Questions in Response to RAI 8089, Question 03.11-11

The remaining questions are all regarding the proposed markup to APR1400-E-X-NR-14001-P (Attachment 2 in the response).

Figure 1. Locations of Dose Points for TID calculation inside Containment

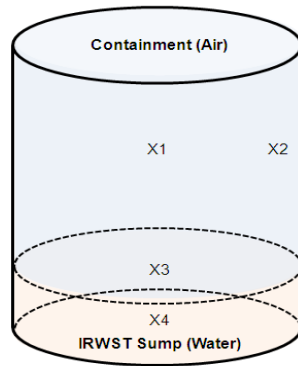
7. In Section 3A.1, the applicant indicates that the dose rate was calculated at the containment atmosphere, containment wall surface, bottom of containment, and in the center of the containment IRWST sump. However, the markup does not specify why these locations were chosen and how the doses from these four locations were used to come up with the TID for components in containment (for example, were all four doses added to come up with a TID value to be used for all components in containment, or how were the individual dose rates assigned to specific equipment).

(KHNP Response) As shown in Figure 1, the four locations evaluated were determined taking into account the installation locations of the components and equipment inside the containment.

The TIDs for each of the components/equipment at these locations, which are calculated using the RUNT-G code, are as follows:

Depending on the location, the resultant TIDs assigned to specific components or equipment were determined for the bounding analysis as follows:

- Components located Above Elevation 100' = TIDs at X4 location
- Components located Below Elevation 100' = Maximum gamma TID + Maximum beta TID at any location (i.e., Gamma TID at X3 location + Beta TID at X2 location)
